**Subject: Derby Street Shops Building 5 – Site Plan and Parking Determination**

This is to advise that we have reviewed the following documents pertaining to the proposed modification to the permits issued in 2018/2019 for work at Building 5 at the Derby Street Shops:

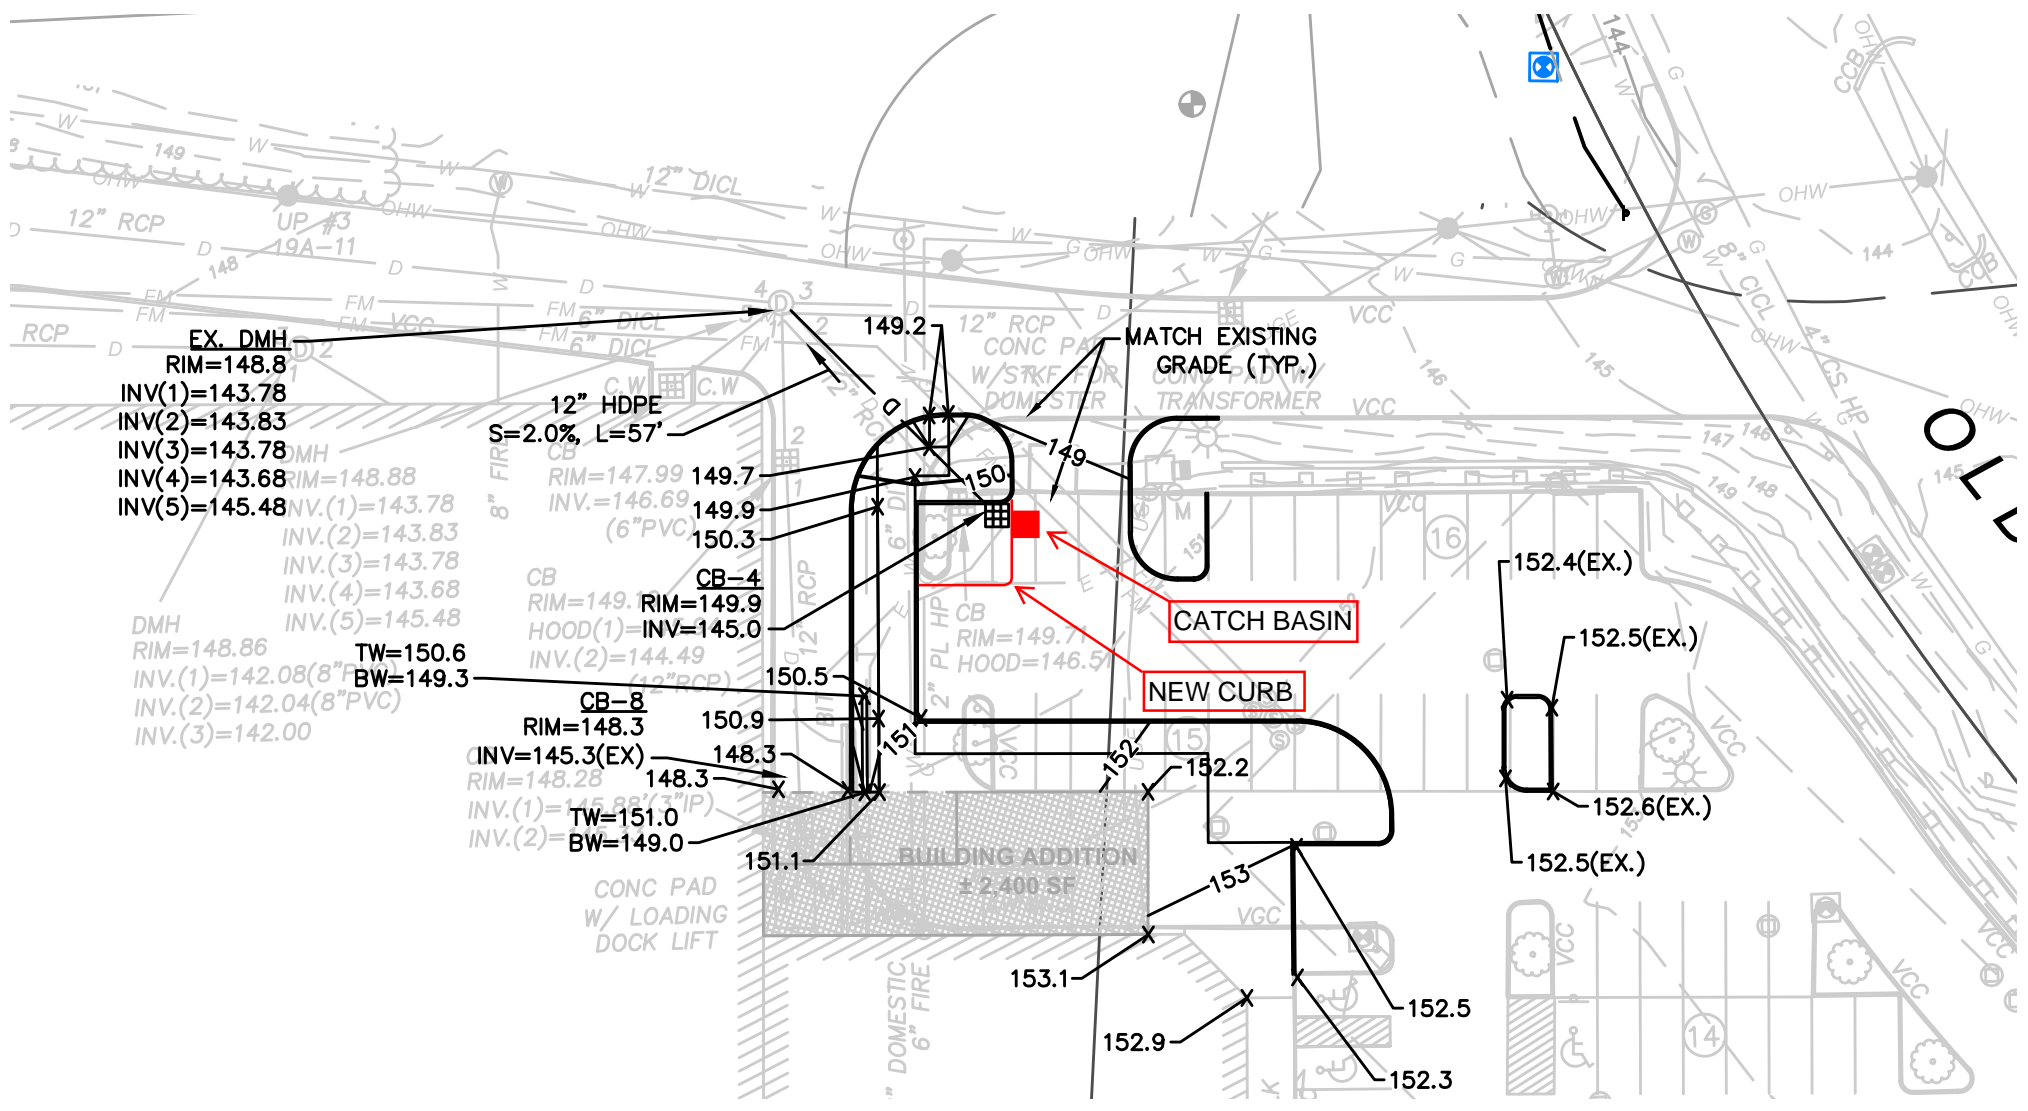
4. We are also in receipt of an April 4, 2021 email from Mr. Jeffrey Dirk, P.E. of Vanasse & Associates. We concur with Mr. Dirk's recommendation to eliminate at least the two parking spaces located closest to the access driveway behind (west) of the building. If these two spaces are eliminated, the catch basin proposed in the western most parking space should be moved directly north/northeast so that it is located along the south side of the access drive as shown on the attached sketch and not within a parking space.
